Recall Bulletin

PRODUCT SAFETY RECALL

SUBJECT: Power Lift Gate Prop Rod Recovery

MODELS: 2008-2012 Buick Enclave
2009-2012 Chevrolet Traverse
2007-2012 GMC Acadia
2007-2010 Saturn Outlook
Built Prior to March 1, 2012 and Equipped with Power Lift Gate (TB5 or E61)

2878222

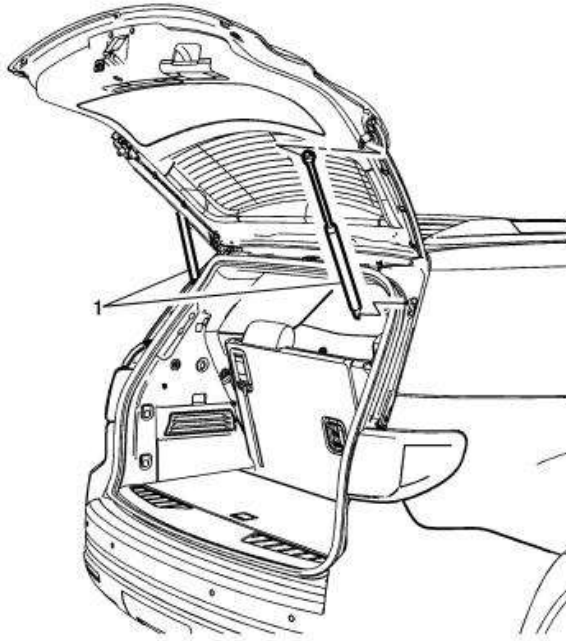
Note: GM engineering has determined that improved durability of the lift gate strut can be realized by installing the strut assembly with the rod end facing downward (attached to the lift gate) when the lift gate is in the closed position. In this orientation, dust and dirt does not collect on the strut housing to rod seal, which can cause wear on the seal.

Note: When replacing or repositioning the lift gate struts, install the strut assembly with the strut body end attached to the vehicle body and the rod side attached to the lift gate (1).
